# CONNECTION ASSESSMENT & APPROVAL PROCESS

## Preliminary Assessment Report

**Project:** *High Falls GS Redevelopment*

**CAA ID 2002-069**

**Figure 2. Exciter Time Response Test**

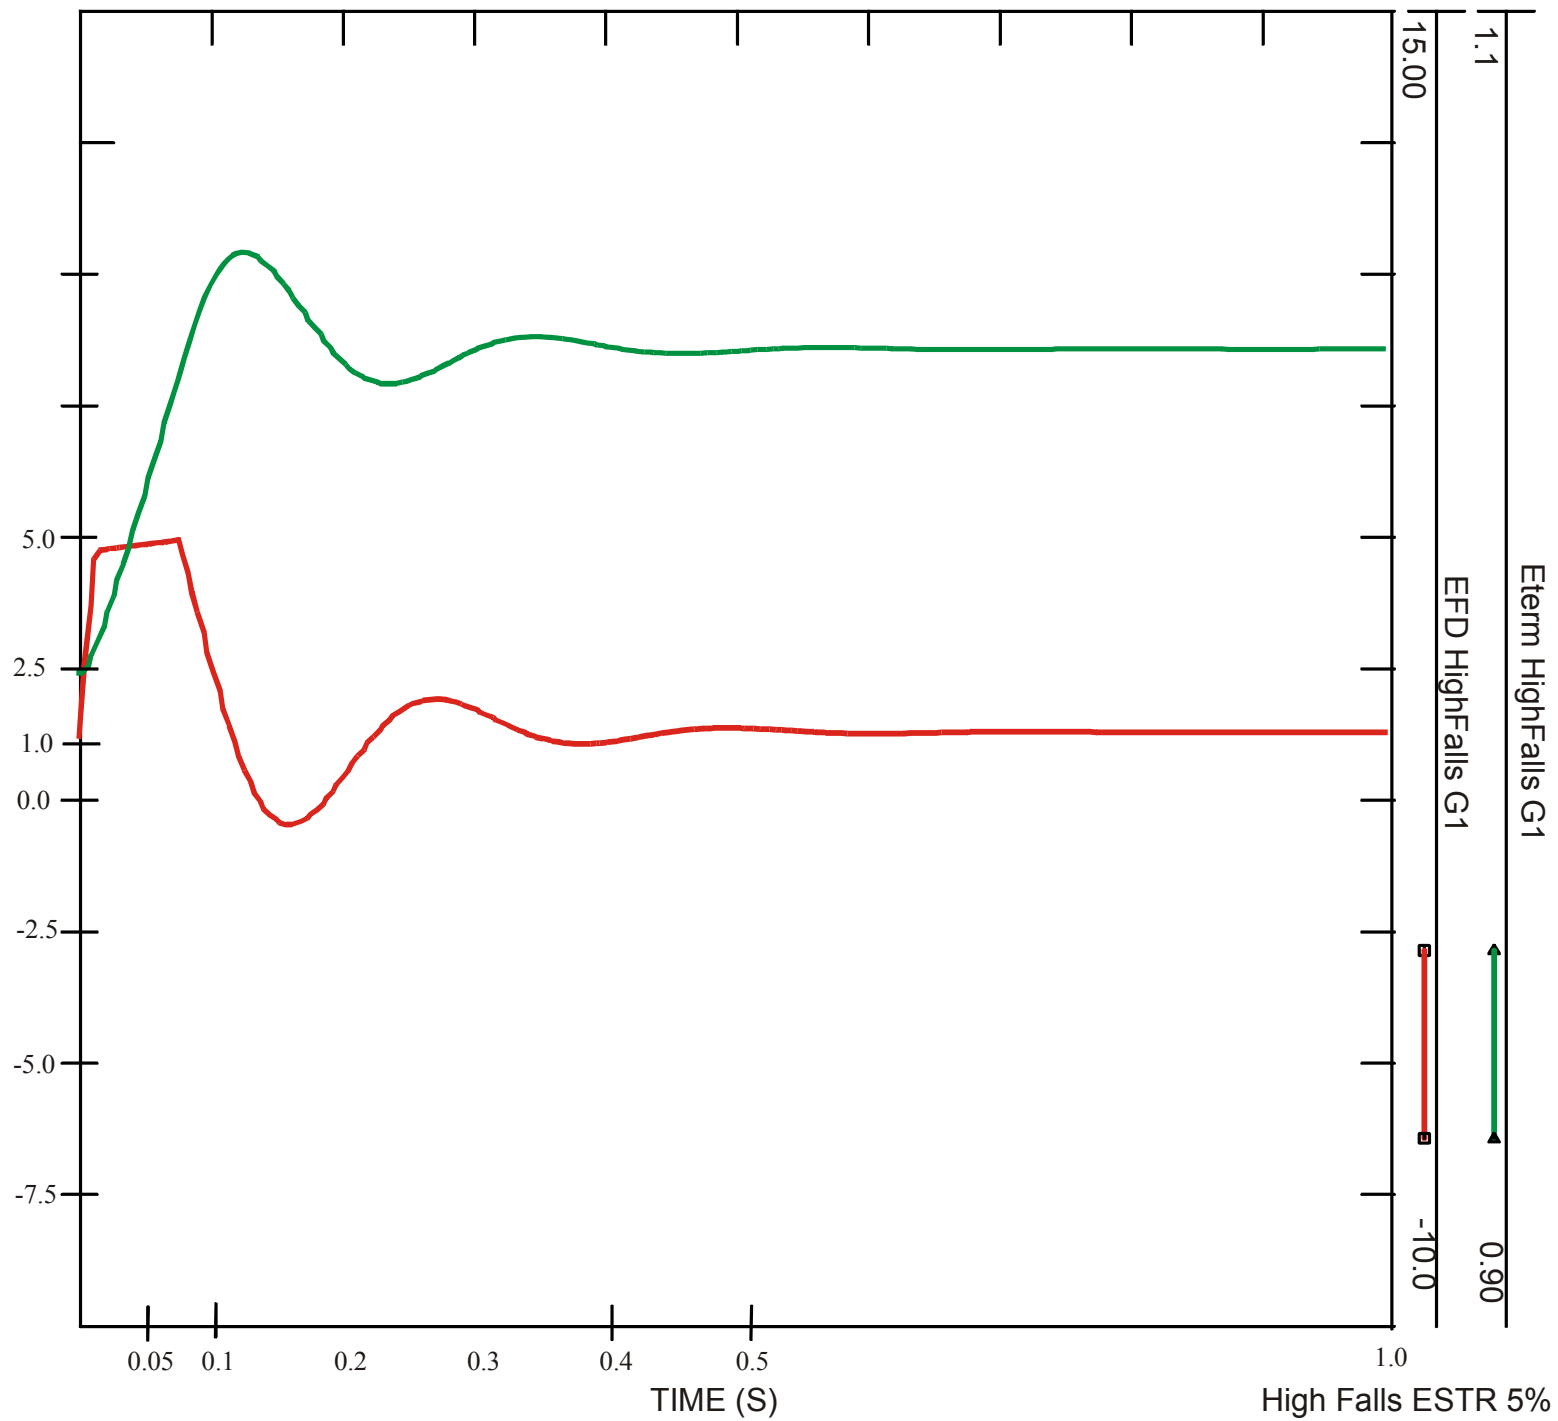
Dynamic simulations were performed to verify that the transient response of the new units excitation systems meets this particular rule. The results of the exciter system voltage response test to a 5% step change in terminal voltage are displayed in Figure 2. Examination of the plots indicate that:

- the exciter field voltage reaches 95% of the excitation ceiling voltage in less than 50 ms, thus meeting the above-mentioned requirements,
- the exciter ceiling voltage exceeds the Market Rules requirements<sup>1</sup> and
- the proposed exciter provides adequate damping of system oscillations.

Although, the damping provided by this exciter is adequate the exciter gain must be set to about 200 in order to meet the requirement described under reference #13. This will result in a more oscillatory transient response for the new units, thus necessitating the installation of a stabilizer

The IMO requires that a power system stabilizer must be provided with each unit excitation system, but acknowledges that meeting this requirement at the time of commissioning may jeopardize the planned in service date of the development.

3. The connection applicant must install a power system stabilizer on each High Falls unit not later than August 1, 2003,

4. Coincident with the installation and tuning of the power system stabilizer the exciter gain must be set to 200 and the exemption granted under point 2. above will expire.

Figure 5. GLP System

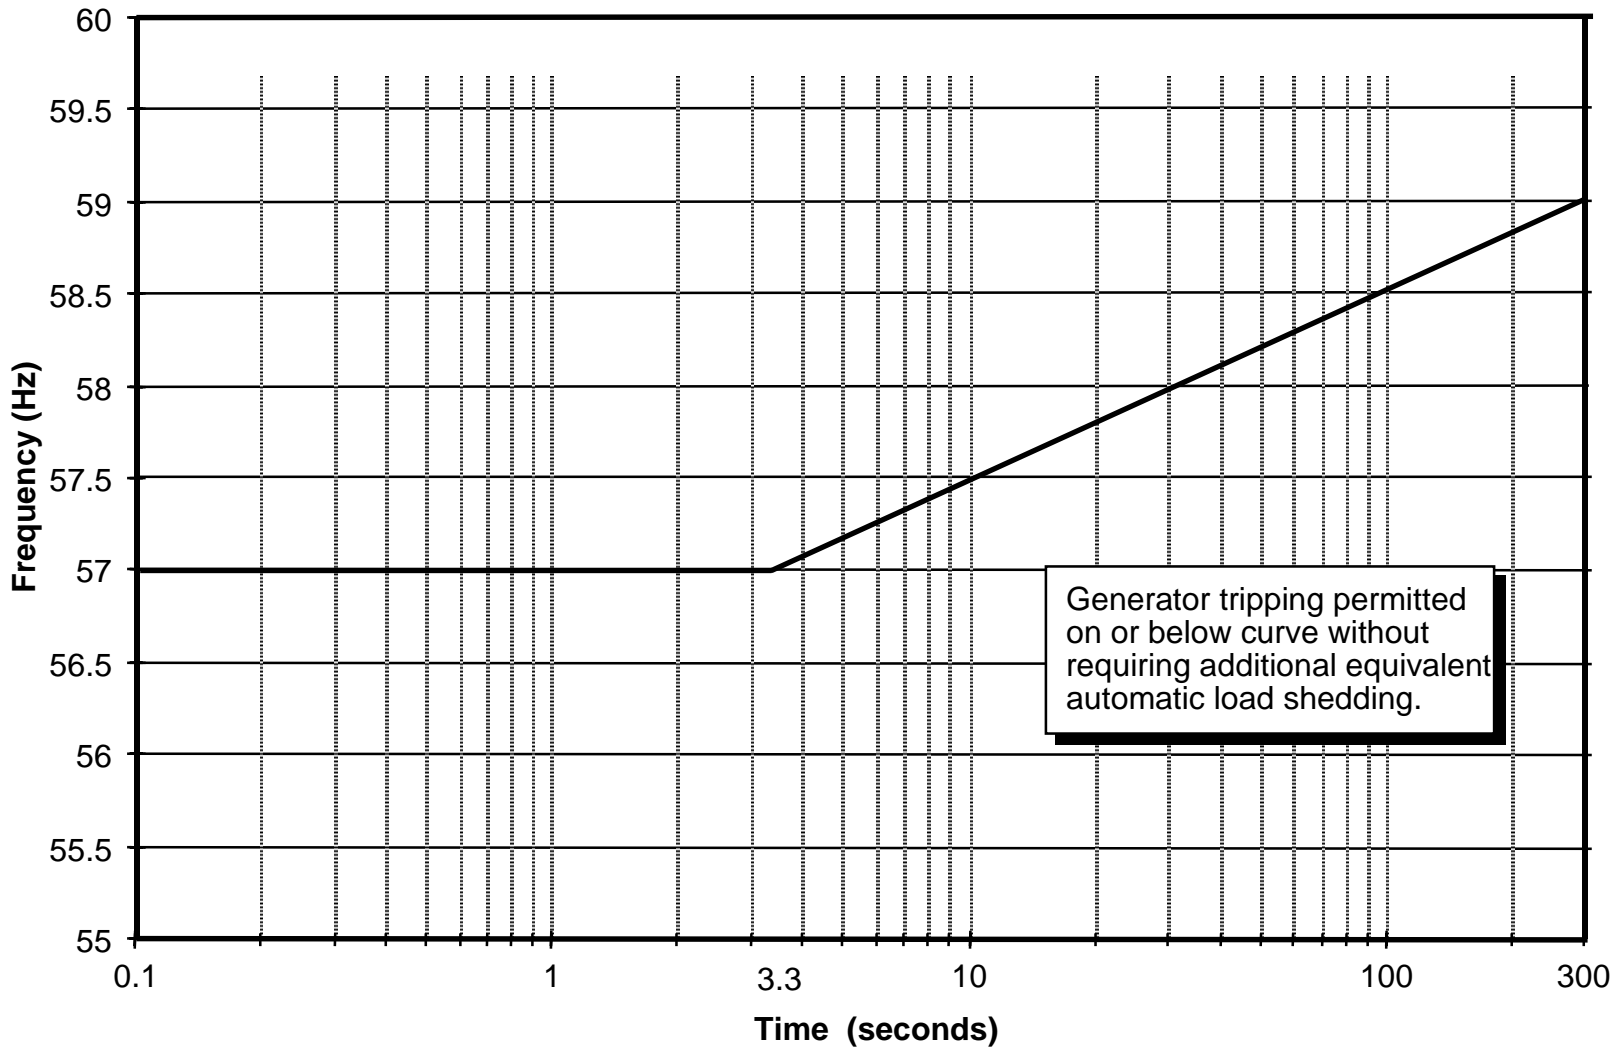
It can be concluded from these results that the 115 kV No.1 High Falls will become limiting during summer for a contingency associated with No.2 High Falls 115 kV circuit. To address this thermal overloading it is required to either:

The IMO requires that GLP-Generation Division initiate work for either:

- the installation of a contingency based automatic generation rejection scheme which will trip an amount of generation equivalent to the difference between the calculated post-contingency flow on the 115 kV No.1 High Falls circuit and its continuous rating.

- Upgrading the 115 kV No.1 High Falls circuit to a higher rating

**Figure 6. Increment in Power Flows due to the Additional Generation at High Falls**

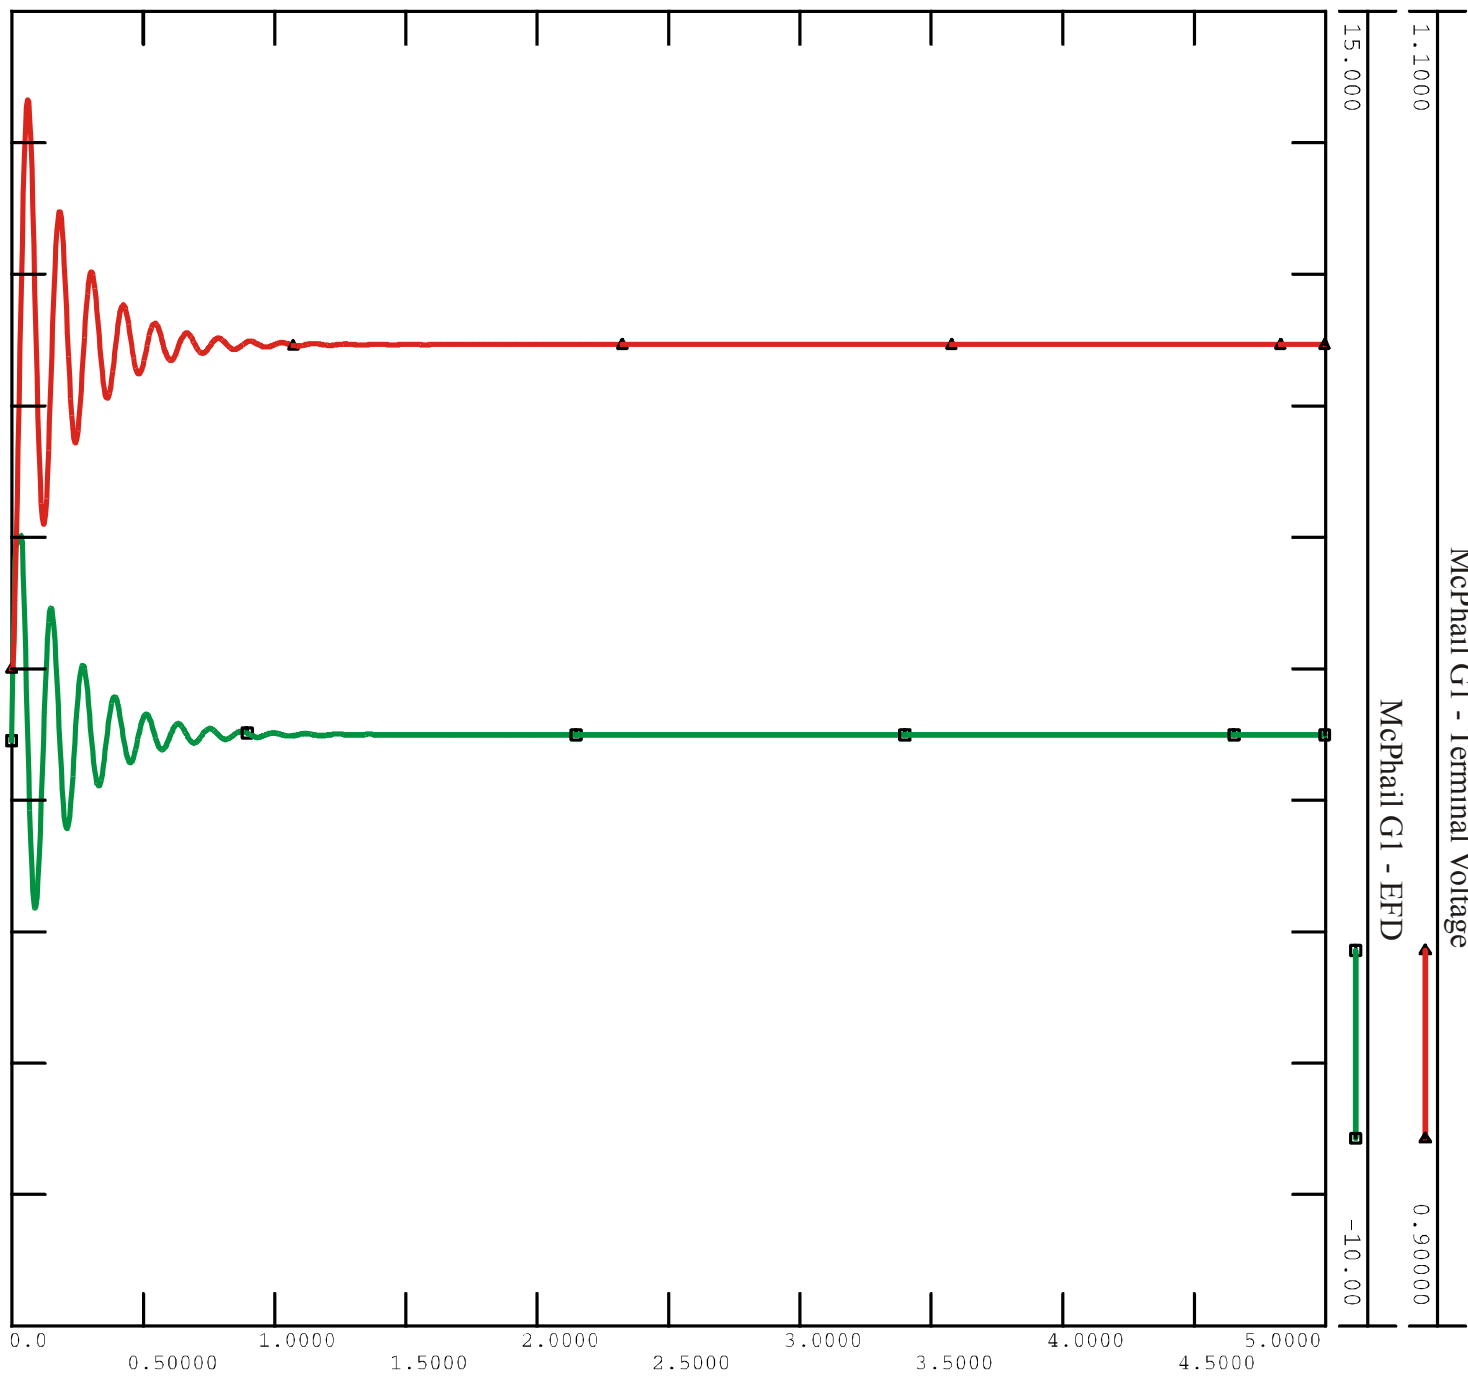
- the flow on each Wawa TS 115/230 kV transformer, with a continuous rating of 125 MVA, would increase by about 11.2 MW but is not likely to result on the overloading of these transformers, and
- the additional generation will result in a slight reduction in the East-West transfer east but will contribute to flow west on the East-West interface.
